Re: Shell Gulf of Mexico Inc.
Noble Discoverer – Chukchi Sea
Application to Revise OCS PSD Permit to Construct No. R10OCS/PSD-AK-09-01

Attachment: Response to December 31, 2012 Request for Additional Information

Best Available Control Technology (BACT) Documentation Issues

Figure 1. FD-1 on 9/9/2012

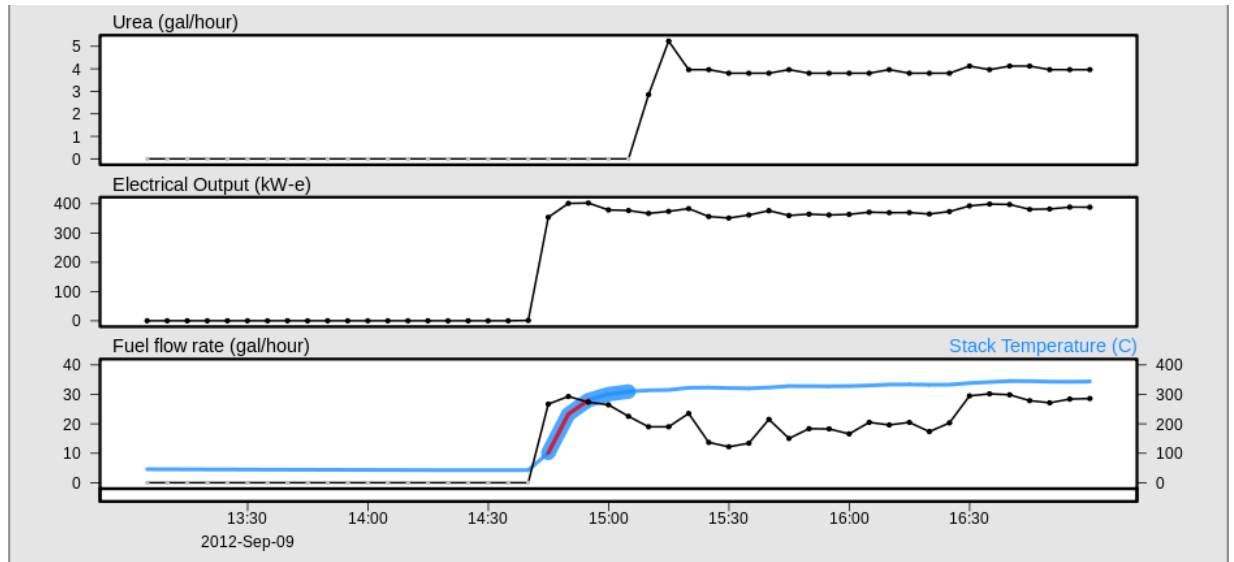
1. Page 31. Data and analysis supporting the statements made regarding the portion of Discoverer main generator deviation time which is attributable to operational problems with the E-PODS.

Figure 1 demonstrates an example of when start up conditions result in a deviation from permit condition requirements. The urea flow, electrical output, fuel flow, and stack temperature from 13:00 to 14:40 indicate that the engine is off. At 14:45, the electrical output, fuel flow, and rising stack temperature indicate that the engine has been turned on. At this point, the urea flow has not started because the stack temperature has not met the minimum temperature threshold needed to initiate urea dosing. At 15:10, the stack temperature has reached the minimum threshold needed to activate urea flow. After 15:10, the engine is operating under controlled emission conditions.
